37/3-02NN 7129 Willow Avenue
(Takoma Park Historic District)

HISTORIC PRESERVATION COMMISSION STAFF REPORT

Address: 7129 Willow Ave **Meeting Date:** 10/09/02
Applicant: Lin & Lezetta Moyer **Report Date:** 09/25/02
Resource: Takoma Park Historic District **Public Notice:** 09/18/02
Review: HAWP **Tax Credit:** Partial
Case Number: 37/3-02NN **Staff:** Corri Jimenez
PROPOSAL: Excavation work & window replacement
RECOMMEND: Approve with conditions

NEW BASEMENT UNDER EXISTING CRAWLSPACE
 MOYER RESIDENCE

PROPOSED LOOK FOR REAR OF:
 7129 WILLOW AVENUE, TAKOMA PARK

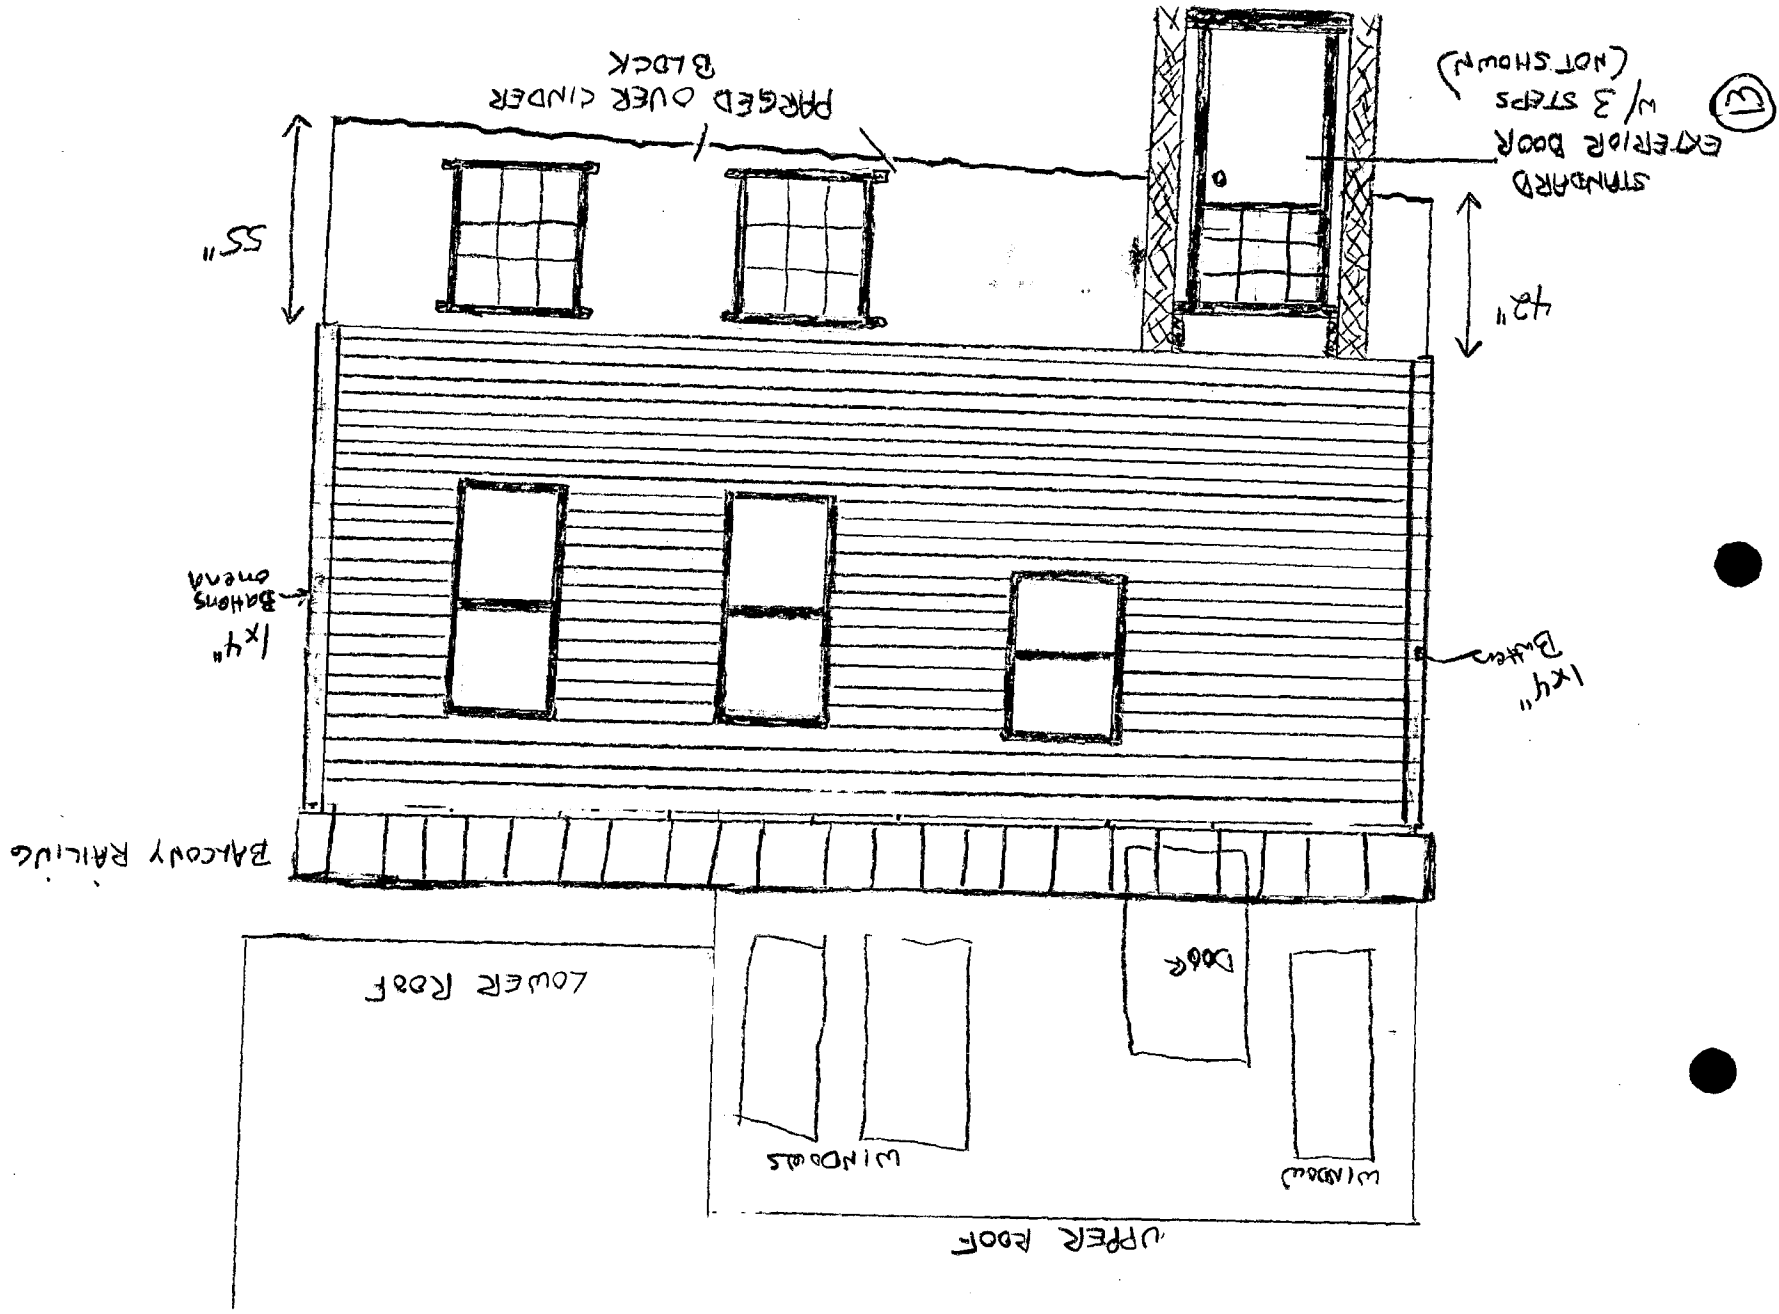
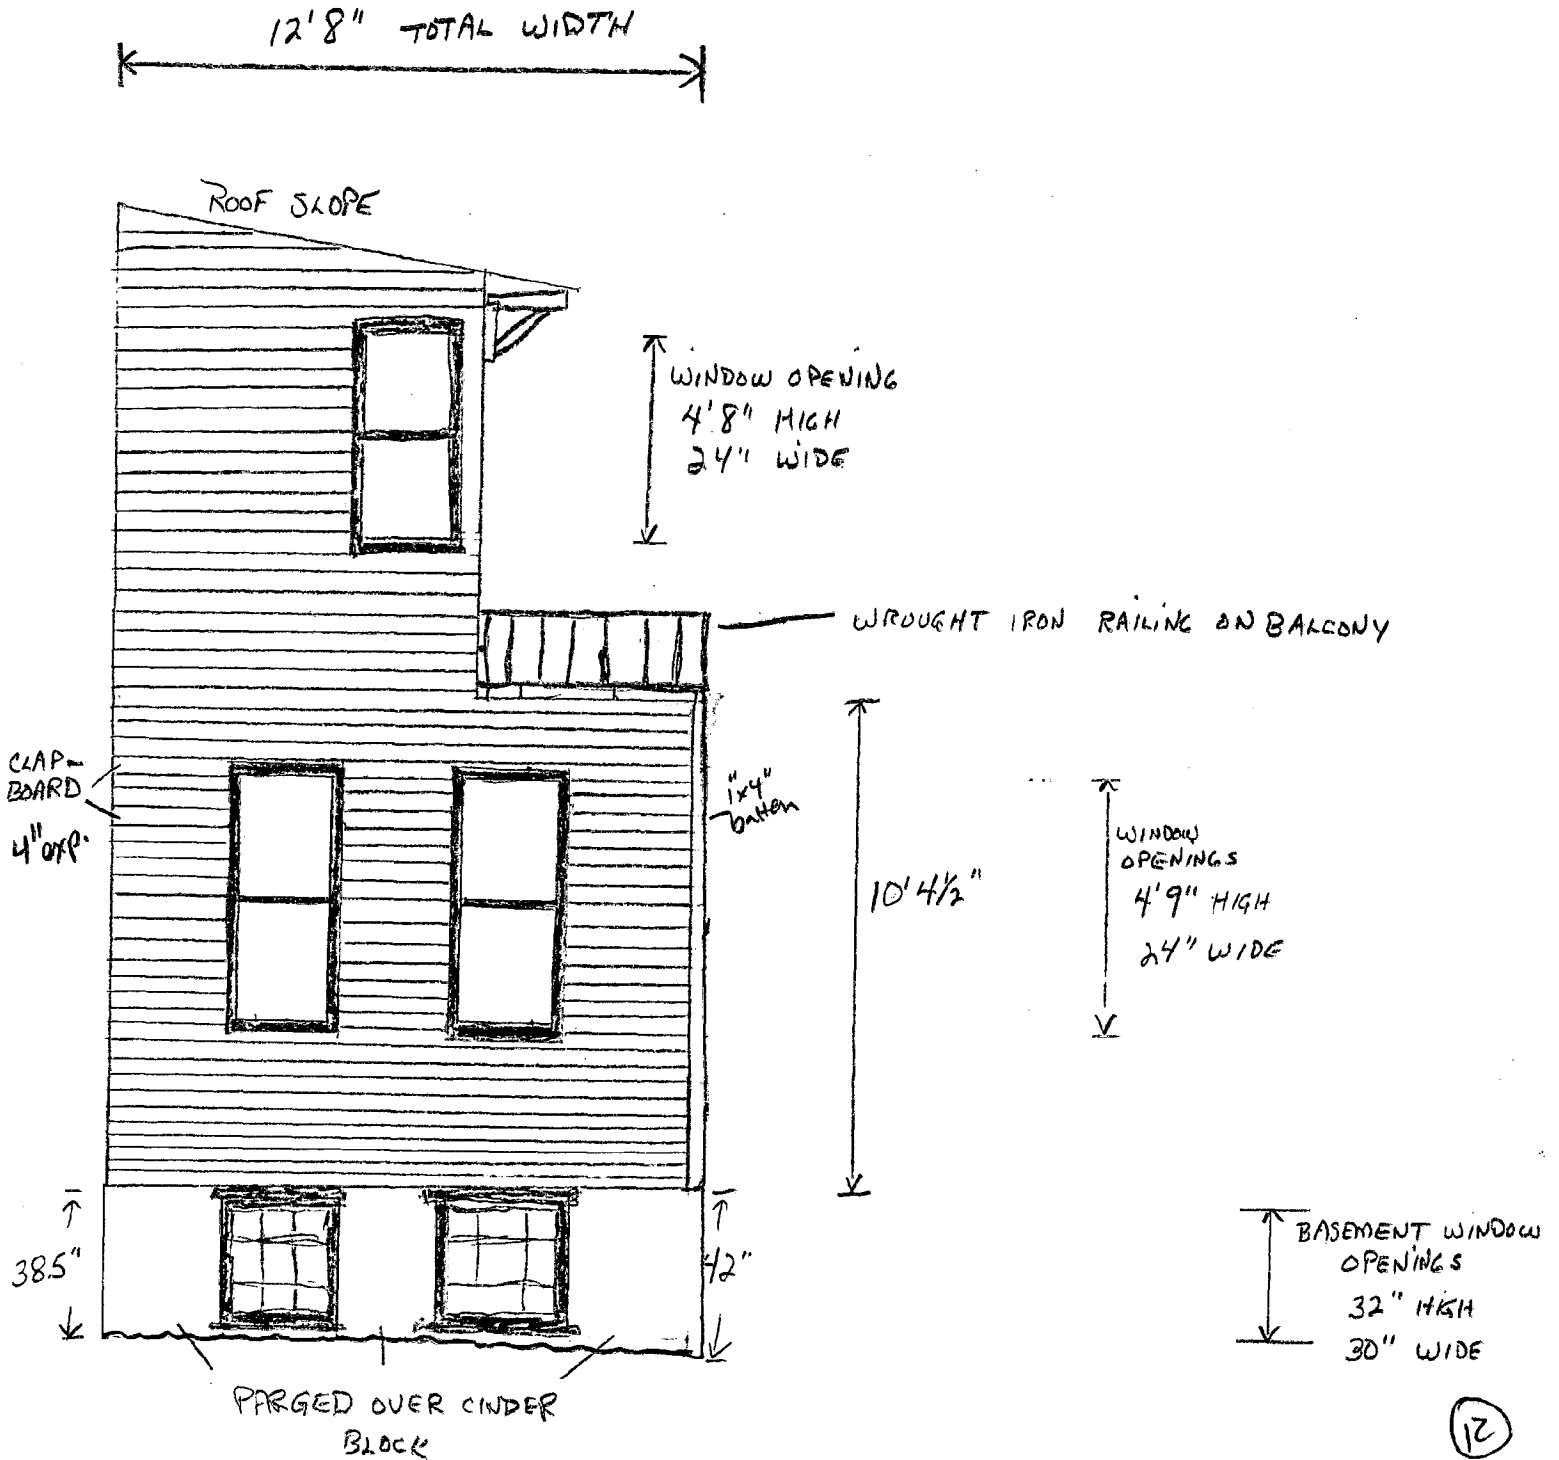
1. The historic windows on the east and west elevations be salvaged, reused or stored on site.
2. Staff will review more finalized elevation drawings of the addition
3. Tree save measures will be undertaken in conjunction with consultation with the City of Takoma Park's arborist.

Historic windows on the west side

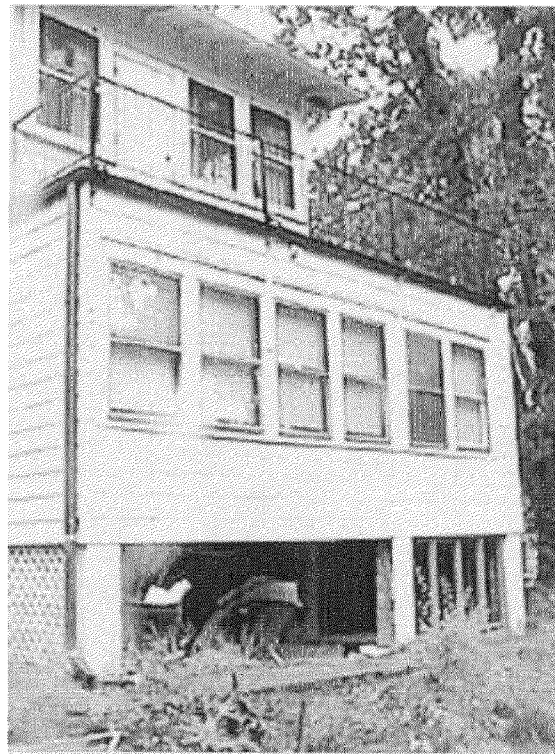
Approved with Conditions: ① The historic windows on the east & west elevations be salvaged, reused, or stored on site; ② Staff will review more finalized elevations drawings of the addition; ③ Tree Save measures will be undertaken in conjunction with consultation with the City of Takoma Park's arborist, and HPC Staff will review and stamp the construction drawings prior to the applicant's applying for a building permit with DPS; and
